# Product Change Notification

Date Issued :	November 11, 2022	PCN Number :	512997
Reason for Change :	Change Supplier		
Description of Change :	Supplier Change : this notification is to inform you about a change of resin suppliers impacting the part(s) attached as per list. No changes will be made to product as part of this change.		
Reason for Short Notice :	Special Request		
Assessment of Change :	Reliability Test Report/s		
Planned Implementation Date :	February 01, 2023		
Sample Availability Date:	November 09, 2022		
Internal Molex Qualification Date :	November 09, 2022		
Last date to request Samples by Customer :	January 18, 2023		
Traceability Code Markings / Date :	Lot information on label

- Description of change
  - Due to Toray's Flame Retardant shortage, there is a shortage of PA66 glass fiber containing resin, and it is difficult to supply the target connector, so we will switch to Asahi Kasei.

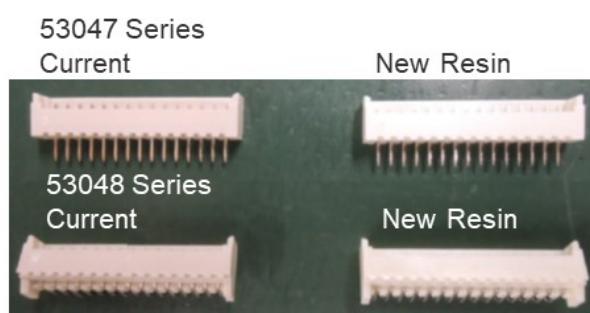
## ➤ Color difference

After changing the resin, the color will be slightly brighter.

➤ Identification: During the first 6 months of production with an alternative material, add an "M" to the end of the traceability number on the label (see photo) to identify products made with the alternative material.
